**LSDP, ONE UPTOWN
STAFF SUMMARY REPORT**

LOCATION:	4205 S Champions Drive, 5102 W Pauline Whitaker Parkway
LAND OWNER:	Hachem Investments, Inc.
DEVELOPER:	Hachem Investments, Inc.
APPLICANT/ ENGINEER:	Harrison French & Associates, Ltd.
ZONING DISTRICT:	U-COM (Uptown Commercial Mixed-Use) and R-O (Residential Office)
PLANNED USE:	Retail, Restaurants, Office Space
REQUEST:	Large-Scale Development Project approval
AUTHORITY:	Article III of Chapter 14, Rogers Code of Ordinances
DESCRIPTION:	64,454-sf mixed-use building on 1.97 acres
WAIVERS:	Yes: Required number of bicycle parking spaces, maximum building frontage, exterior building materials, upgrade existing street, and 10' sidepath with 6' greenspace.

RE: ONE Uptown
Rogers, AR
LSDP # PL201801227

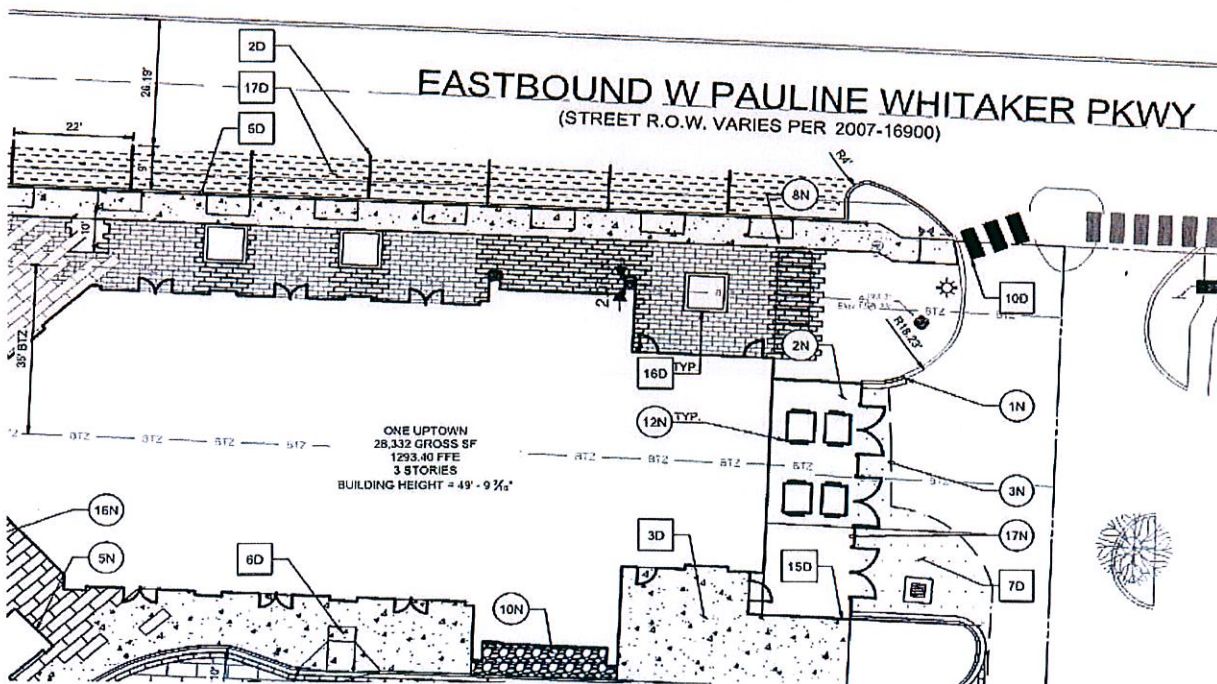
Waiver Request 4: *Allowable Adjustment*

A 2' encroachment into the BTZ. In working with the risk reduction department for fire access and keeping the utilities in mind, our building now falls about 2' into the Build-To-Zone for the two small areas shown below in red. We would like to request a staff adjustment for this as it should not interfere with the site function or usability.

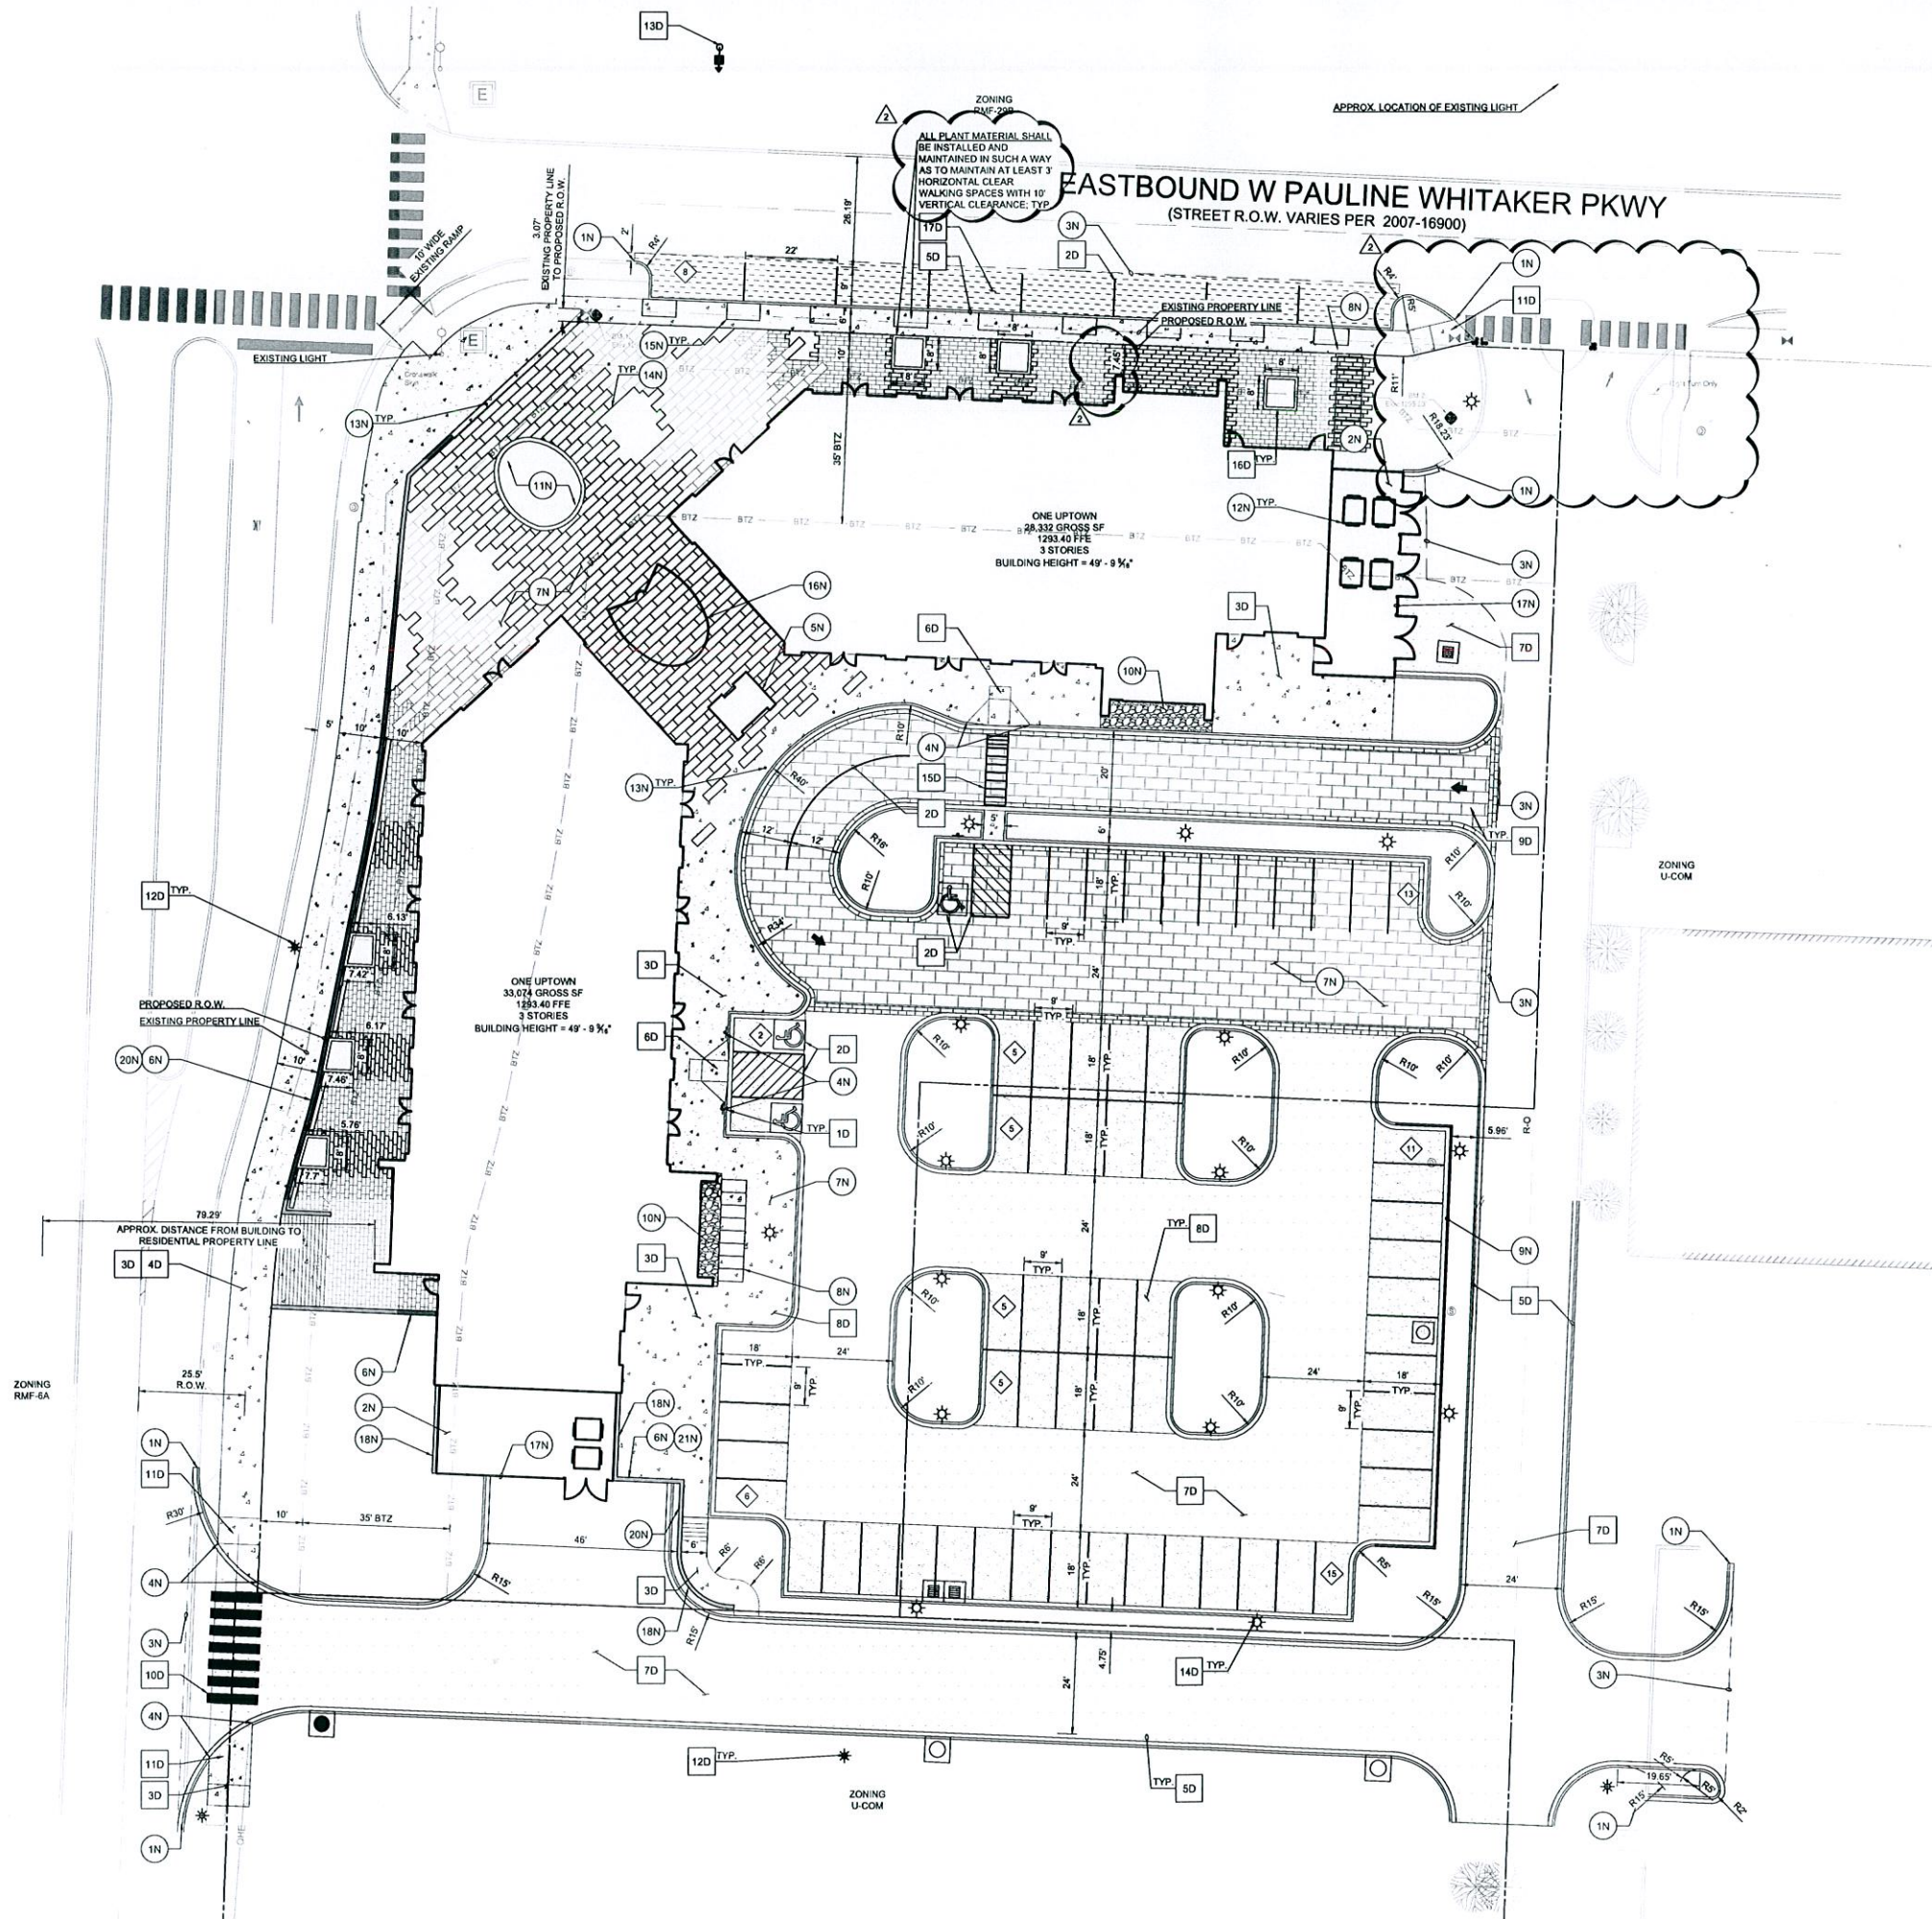
On January 14, 2019 we received a comment to provide road improvements to Champions Drive bordering the parcel where the retention pond for the referenced project is proposed. After discussion with Mr. Cobb we would like to request a waiver of these road improvements due to no rational nexus for this request. We propose the road improvements requested along Champions Drive to be completed as development occurs in the parcels bordering Champions. Please consider our waiver request.
